SB-GA8-2005-23

Issue 8

Service Bulletin

Forward Cargo Door Slide

Figure 3: A worn slider indicating where to measure.

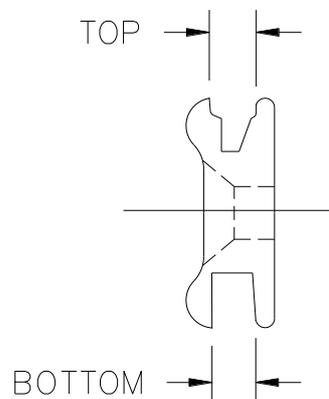
4. Figure 3 shows how a worn part normally looks and where to measure the groove width. The TOP and BOTTOM profile differs on a worn part and as such both the top and bottom slide grooves are to be measured with a calliper.

5. Measure the groove width and if the groove is wider than 0.145" at any point along the slider, or if the part is cracked or excessively worn, a new slider, Item 1, must be fitted.
6. Irrespective of Item 1, Items 2 to 7 MUST be fitted as shown in Figure 4 and listed in Table 3.

Figure 5: Checking with the Forward Slide Gauge. Note that all four corners require checking.

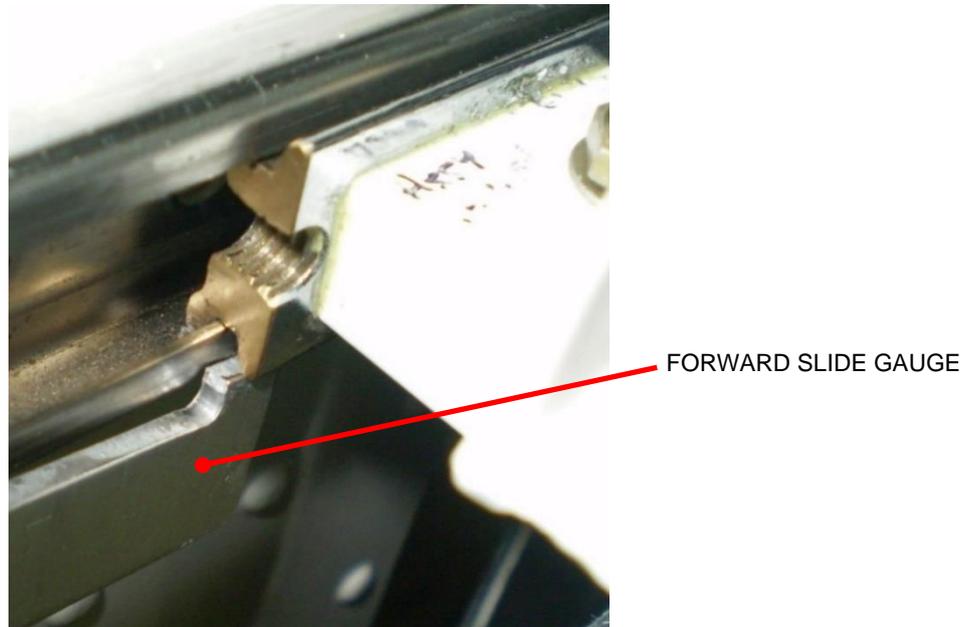
1. Open the Rear Cabin Door handle so that the door swings out to gain access to the slider (see PART A1, Step 1).
2. Try to insert the Forward Slide Gauge (Item 8 in Table 3) between the slider and the track as shown in Figure 5 and Figure 6 below. Standard Feeler gauges made up to 0.098" (0.023"+0.024"+0.025"+0.026") may also be used.

3. If it is possible to fit the Forward Slide Gauge or feeler gauge between the track and slider (as shown in Figure 6 above) at any of the four corners carry out PART A1, Step 2 through 4.
OR
4. If Item 8 (or standard feeler gauge) is unavailable, carry out the inspection under PART A1, Step 2 through 4.

Figure 8: Rear Door Handle Mechanism - Inspection Areas.

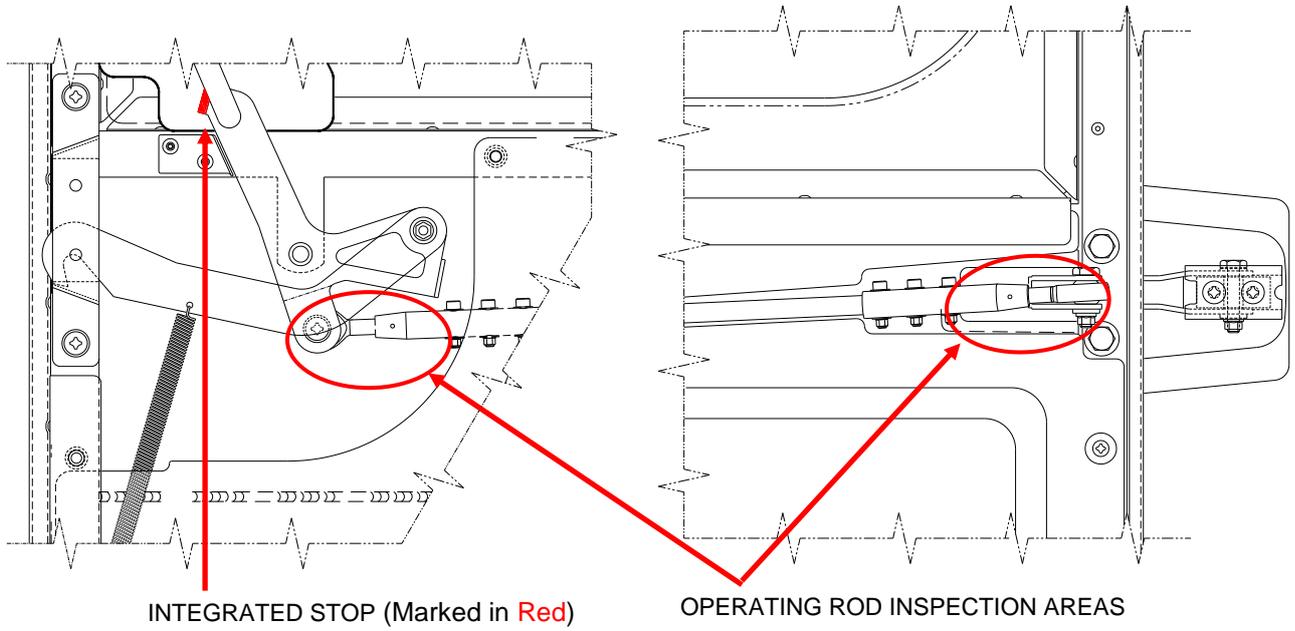
3. Inspect threaded studs and rod ends at both ends of the operating rod as shown in Figure 8. If there is any indication of bending:
 - i. For actuation rods fitted with female rod ends, do PART B3.

- ii. For actuation rods fitted with male rod ends, replace the parts with new Item(s) 9-B, then repeat the inspections and necessary rectification actions detailed in PART B2 and B3.

Figure 10: Rod End Fitting Installation FWD (Left) and AFT (Right). Some parts omitted for clarity.

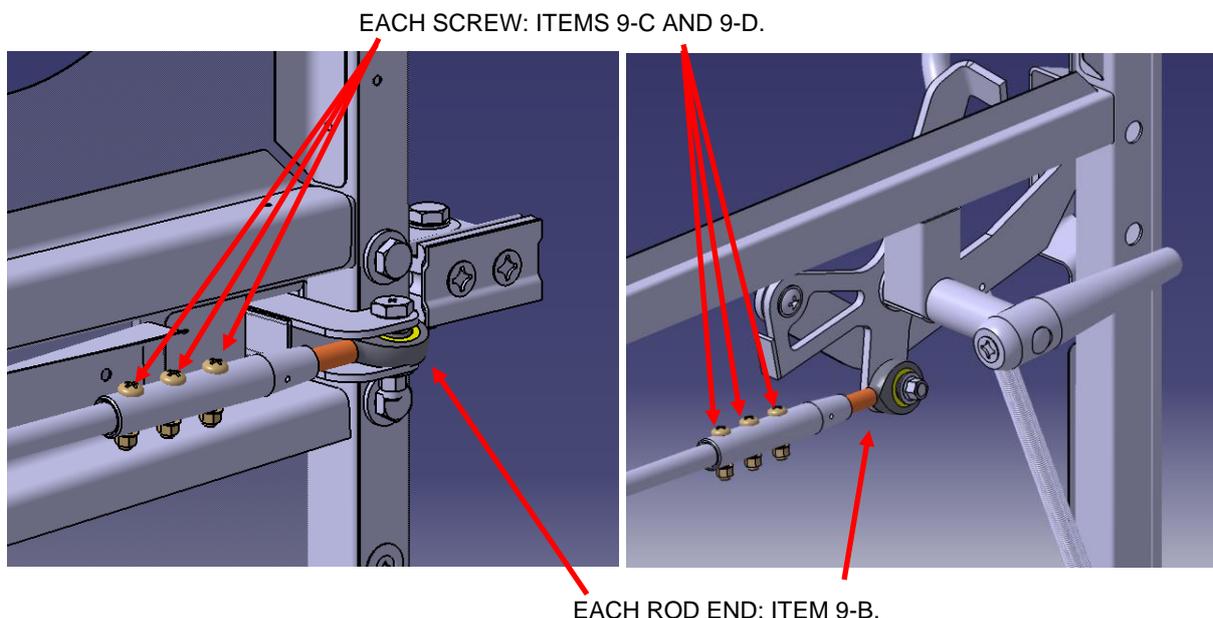
- i. Cut 0.625 inches (15.9 mm) from each end of the existing Operating Rod.
 - ii. Temporarily fit the Rod, Fittings (Item 9-A) and rod ends (Item 9-B) to the door as shown in Figure 10.

- iii. Rotate the fittings so that the screws are vertical, as shown in Figure 10. Match-drill the rod to the Fittings (Item 9-A). Drill size #28 (0.1405 in).

- iv. Install screws, trim any excess thread below nuts and de-burr. Ensure 1.5 full threads extend beyond the nut.
 - v. Remove Fittings (Item 9-A) from the rod. Apply compound C1 and do the final assembly of the AFT Fitting (Item 9-A) as shown in Figure 10.

Figure 14: Pivot Arm Clearance

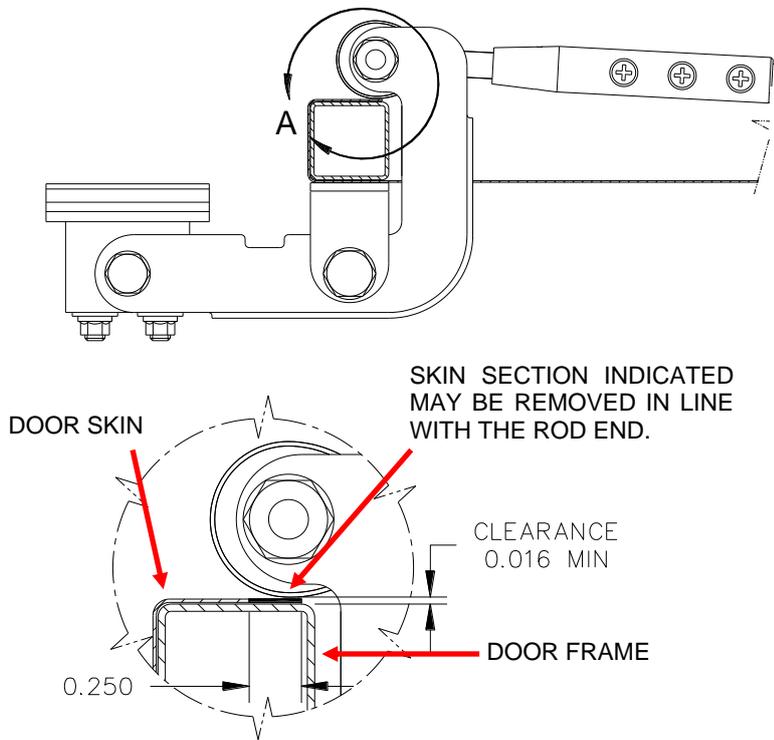
1. Only Pivot Arm shown for clarity.
2. Rework using blending guidelines of AC43.13-1B Chapter 6 Section 7 and 10.
3. Ensure rod end and rod have a minimum clearance of 0.040 in from pivot arm.
4. Restore surface protection IAW Service Manual using compounds C5 and C6 (Table 7).

Figure 16: Door Trim Clearance

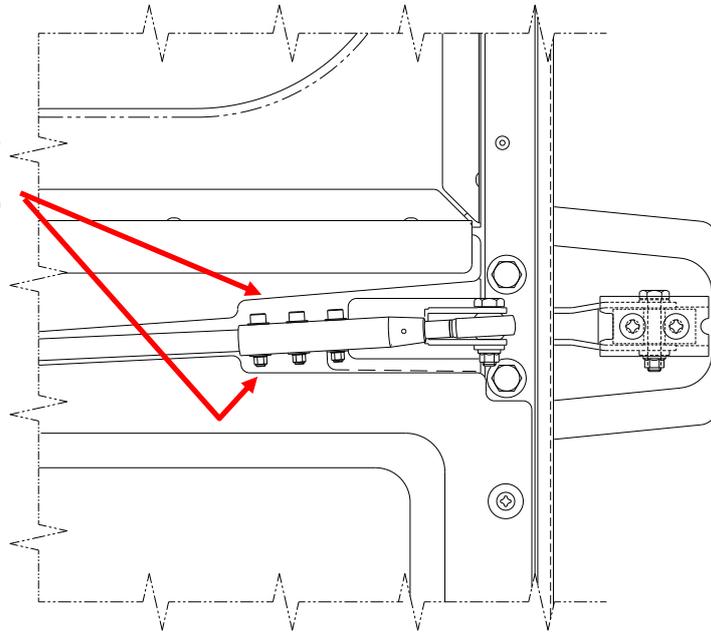
ENSURE MINIMUM 0.080"
CLEARANCE BETWEEN
ROD ASSEMBLY AND
DOOR TRIM.

Figure 20: Maximum permissible trimming of the Centre Cargo Door Rail (GA8-521022-023). All dimensions are in inches.

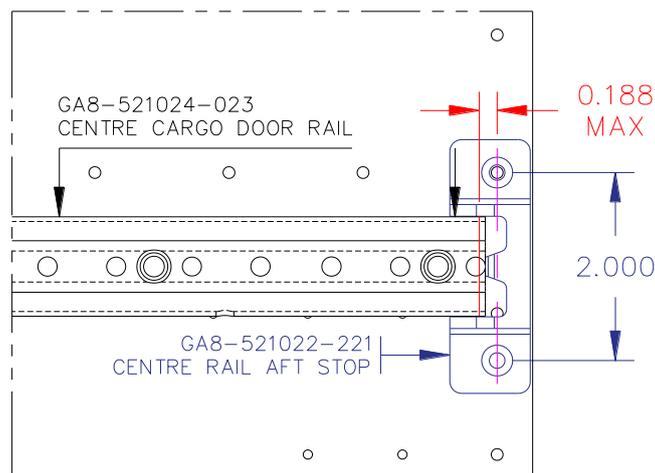
5. Drill a hole 2.000", below the rivet location drilled out in PART D1, Step 3, as illustrated in Figure 20. The diameter of the hole should be between 0.165" (4.2mm) and 0.169" (4.3mm). The lower hole existing in the Centre Rail Aft Stop (P/N: GA8-521022-221) can be used as a guide to mark this location.

6. Trial fit the Centre Rail Aft Stop. If the centre tapered feature of the component overlaps with the Centre Cargo Door Rail, it is permissible to trim (or notch) the aft end of the Centre Cargo Door Rail to the maximum dimension shown by the red trim line in Figure 20 (i.e. 0.188" forward of the Centre Rail Aft Stop attachment holes). If trimming the of Centre Cargo Door Rail is to be conducted in situ, it is recommended that a thin piece steel sheet is placed between the fuselage skin and the Centre Cargo Door Rail, to protect the aircraft's structure during trimming.

Figure 21: Installation of the Centre Rail Aft Stop (P/N: GA8-521022-221) component. View looking at the interior structure of the aircraft's port side fuselage wall.

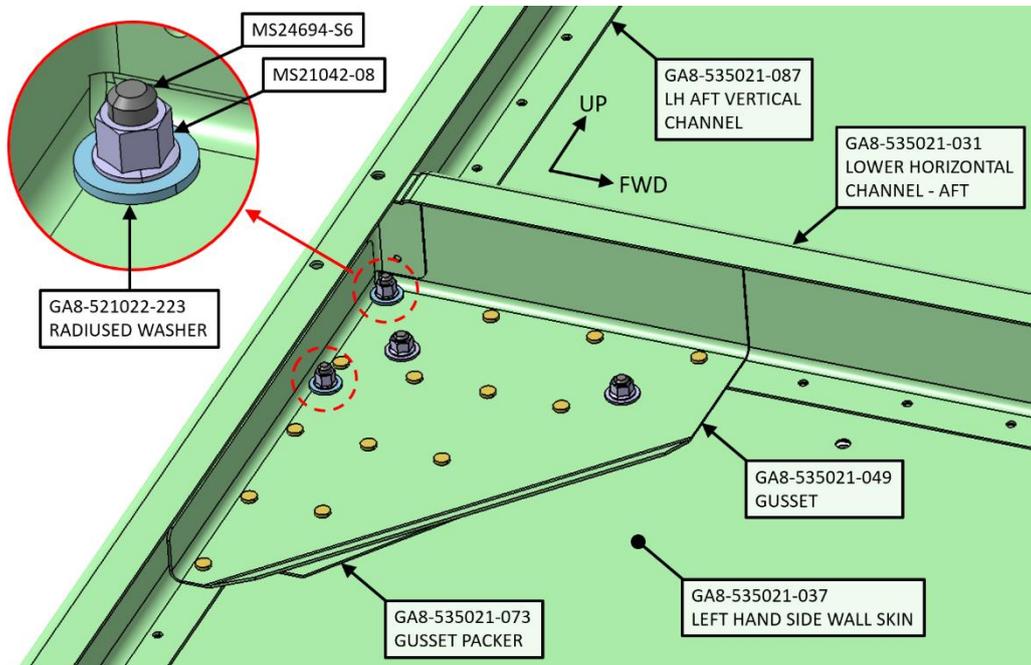
8. Wet install the Centre Rail Aft Stop (P/N: GA8-521022-221) using two (2) off MS24694-S6 screws, two (2) off Radiused Washers (P/N: GA8-521022-223) and two (2) of MS21042-08 nuts as per Figure 21. A sufficient amount of anti-corrosive joining compound (Item C1 in Table 7) should be applied to the faying surfaces of the Centre Rail Aft Stop component the Left Hand Side Wall Skin (GA8-535021-037). Refer to Section 20-10-20 of the GA8 Service Manual for recommended torque values.

Figure 22: Correct orientation of the Forward Cargo Door Guide Assembly. View looking at the exterior surface of the aircraft's port side fuselage wall.

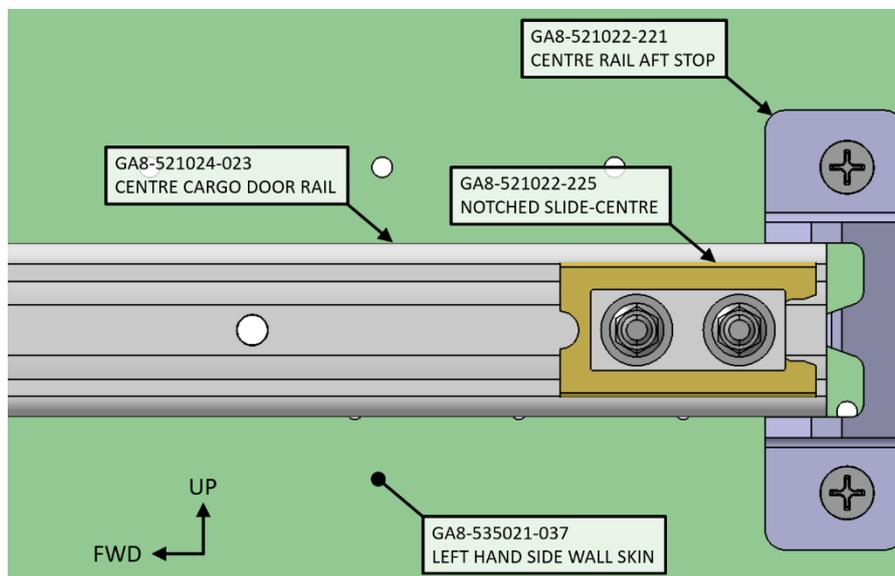
7. Reinstall the new slider assembly and refit the Nylon Track End if it was removed. Note that the notch in Item 1 and Item 2 must be facing aft, refer to Figure 22 of **PART D1** for the correct installed orientation.

9. Replace the existing Slide-Centre (P/N: GA8-521022-149) and Backing Plate (if fitted, P/N: GA8-521022-151) with the Notched Slide-Centre (P/N: GA8-521022-225) and Notched Backing Plate (P/N: GA8-521022-227). Alternatively, if the existing Slide-Centre and Backing Plate components are in an acceptable condition, they may be modified to include the notched feature as per PART D2. Figure 22 shows the correct orientation in which the Forward Cargo Door Guide Assembly should be installed. Note that a replacement split pin is included in the SB-GA8-2005-23-04 kit (refer to Table 6).
10. Assemble the centre rail slider assembly using the New Assembly configuration detailed in Figure 4 and Table 10.

Figure 23: Machining of an existing Slide-Centre (P/N: GA8-521022-149) to form Modified Slide-Centre (P/N: SB-521022-225).

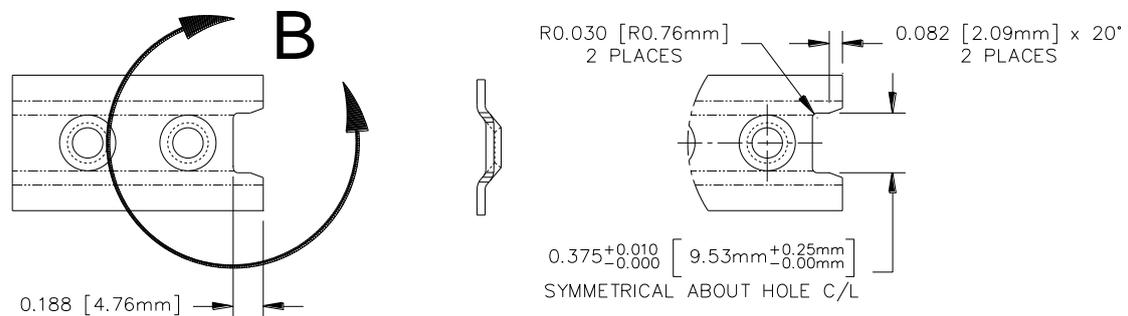
1. Modify an existing Slide-Centre (P/N: GA8-521022-149) component in accordance with Figure 23.

- NOT TO SCALE
- Unless otherwise stated, all dimension are in inches.
- Tolerances: Unless otherwise stated all dimensions are ± 0.005 " [0.13mm]
- De-burr sharp edges.
- Using indelible ink, permanently part mark the Modified Slide-Centre component as SB-521022-225.
